PIC18F87J50 Family Silicon Errata and Data Sheet Clarification

The PIC18F87J50 family devices that you have received conform functionally to the current Device Data Sheet (DS39775B), except for the anomalies described in this document.

The following typographic corrections and clarifications are to be noted for the latest version of the device data sheet (DS39775B):

FIGURE 19-10: I²C™ SLAVE MODE TIMING (TRANSMISSION, 7-BIT ADDRESS)

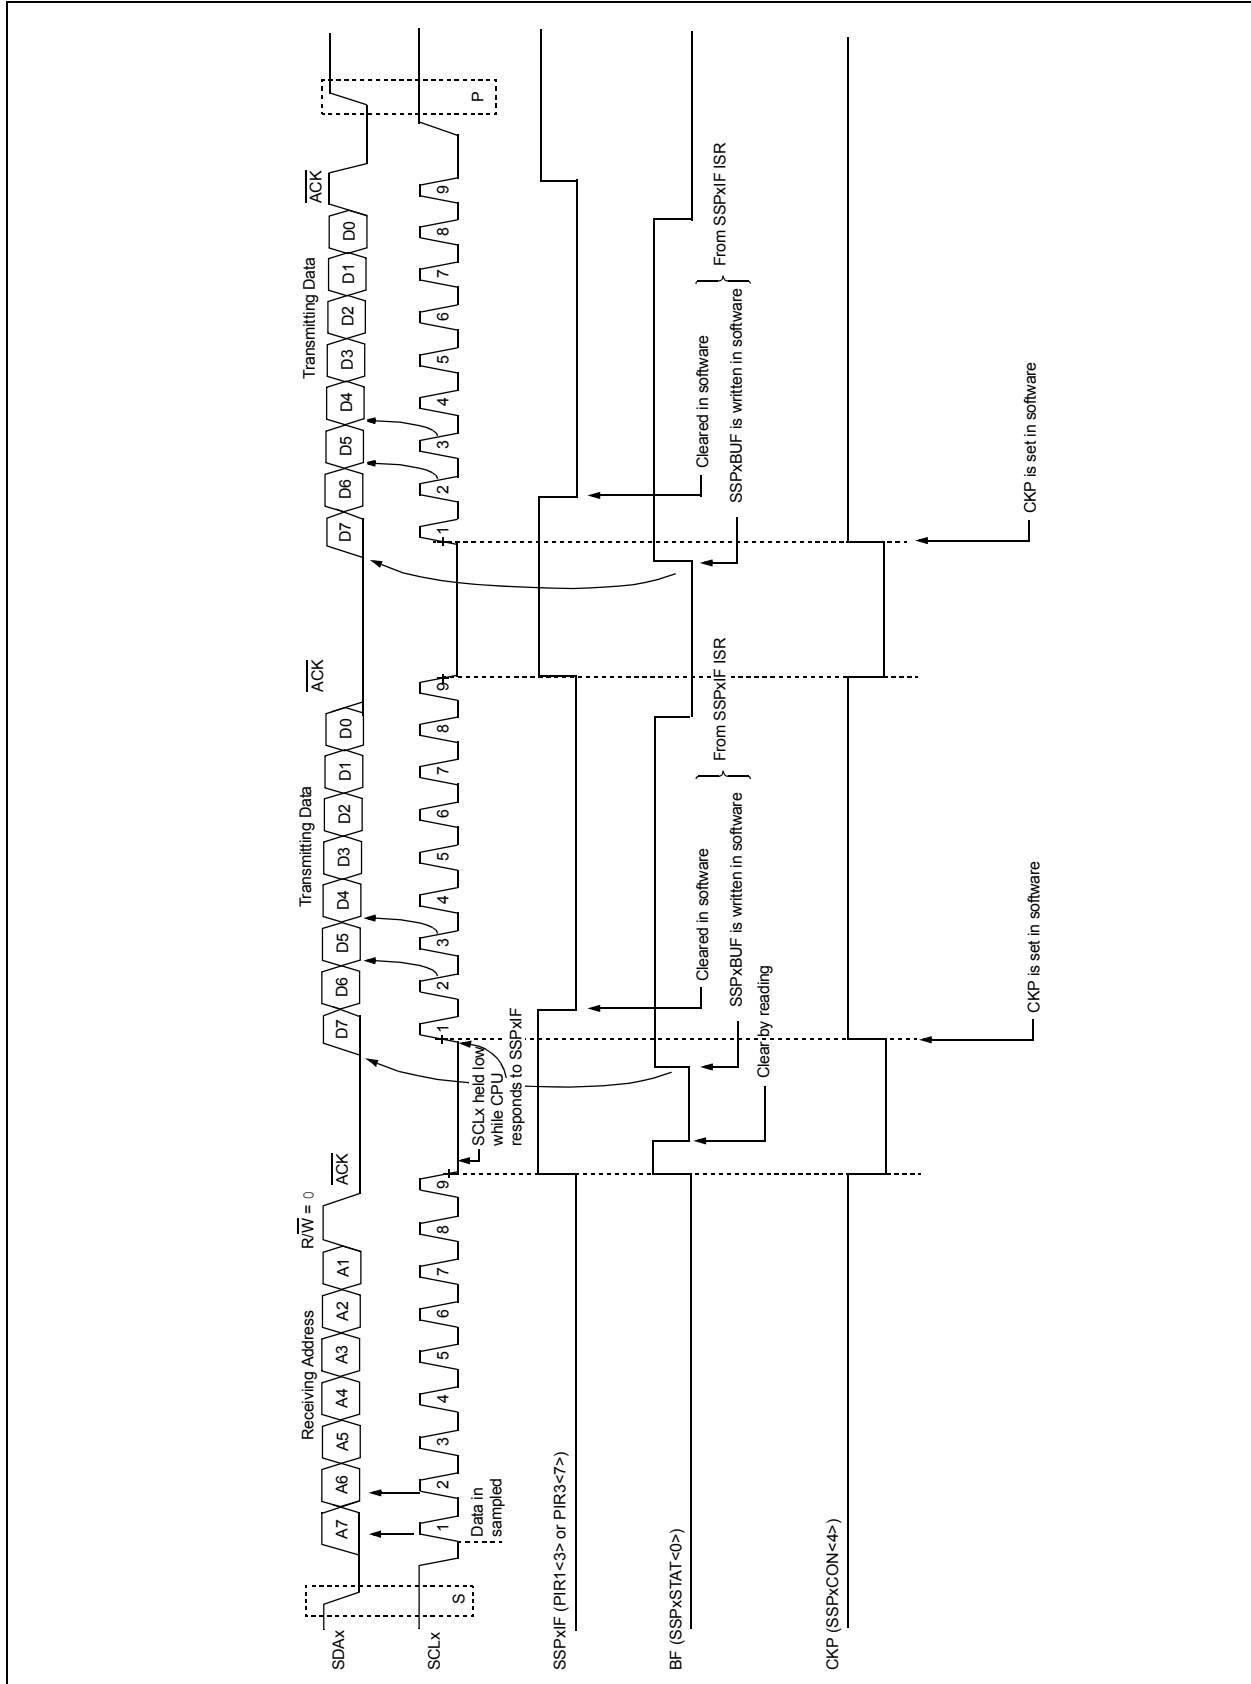
6. Module: Figure 19-10: I²C™ Slave Mode Timing (Transmission, 7-Bit Address)

On page 252, the figure is replaced with the new timing diagram provided in Figure 19-10.
